Household and similar electrical appliances - Safety - Part 2-17:  
Particular requirements for blankets, pads, clothing and similar  
flexible heating appliances

(IEC 60335-2-17:2012/A1:2015 , modified)

This document (EN 60335-2-17:2013/A1:2020) consists of the text of IEC 60335-2-17:2012/A1:2015 prepared by IEC/TC 61 "Safety of household and similar electrical appliances", together with the common modifications prepared by CLC/TC 61 "Safety of household and similar electrical appliances".

## AMENDMENT 1 AMENDEMENT 1

**Figure 114 – Shape of the test piece for the tensile test**

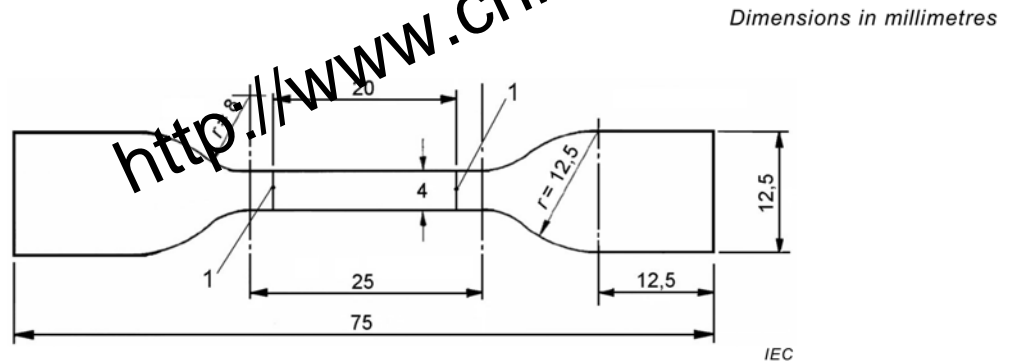
**21.113.1** Twelve samples having the shape as shown in Figure 114 are stamped from the **supplementary insulation** or **reinforced insulation**, six from the longitudinal direction and six from the lateral direction. If the insulation is integrated with the fabric supporting the conductive threads, the test is not carried out.

Add the following new figure:
